**Office of the Principal Chief Conservator of Forests (Head of Forests Force),
Maharashtra State**

No. Desk-17/**FA-S1/PTD-119248/Gadchiroli/1504**
Nagpur- 440 001, Date - **17/08/2023**

Sub:- Diversion of 54.274 ha. of Reserved Forest and Protected Forest in favour of Ministry of Road Transport and Highway, National Highway Division, Gadchiroli for Up-gradation to 2/4 lane with paved shoulder configuration of Gadchiroli-Allapalli-Sironcha of NH-353 C from Gitali-Mosam-Zamela Nalla in Gadchiroli District in the State of Maharashtra-regarding.

Clarification and Compliances

GEOREFERED TOPOSHEET MAP LAND FOR COMPENSATORY AFFORESTATION

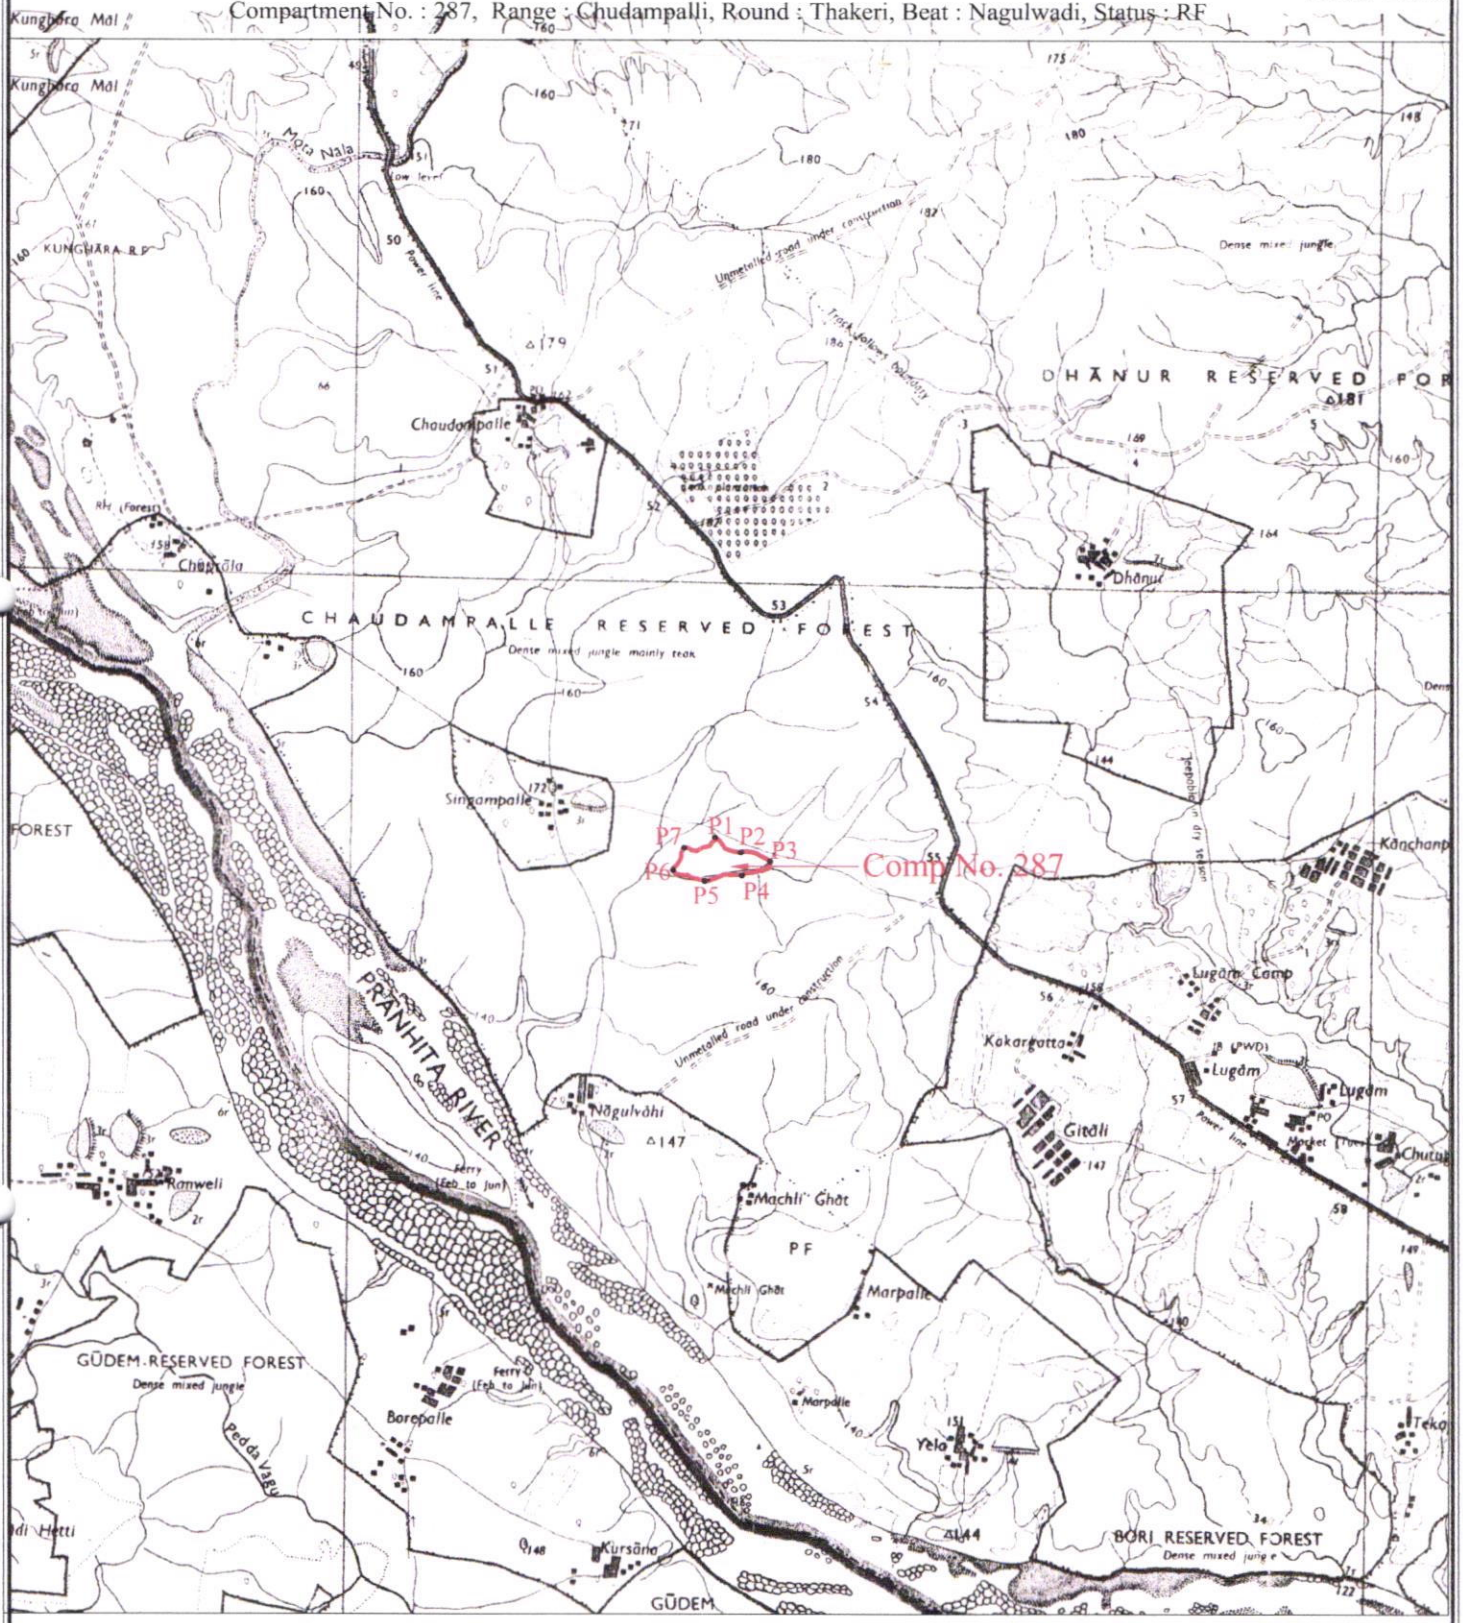
3.	It is observed that the 30.00 ha. of CA area falls in Chaprala Wildlife Sanctuary. The relevant excerpts from the concern Management Plan showing scope of taking up plantation in sanctuary area or permission from CWLW shall be submitted.	As per the compliance report submitted by the Deputy Conservator of Forests, Allapalli Forest Division, Allapalli and the Conservator of Forests (T.), Gadchiroli the relevant excerpts from the Management Plan of Chaprala WLS has been attached along with permission from CWLW. As Compartment no.283 is not due for afforestation work as per management plan the CA area of 12 hectare will be taken up in compartment no.287, which is mentioned in management plan of Chaprala WLS and afforestation work can be taken up in this compartment. Track details of compartment no. 287 for CA land have been updated. Requisite information/documents/KML file regarding the above are enclosed as Annexure-II .

is selected as per this criterion. The CA area at the periphery of the forest boundary is not available. Further, the CA area is duly chosen by RFO and checked by DCF office. CAMPA, Model No. 5 will be used and CA area will be properly protected by the suitable protection structure.
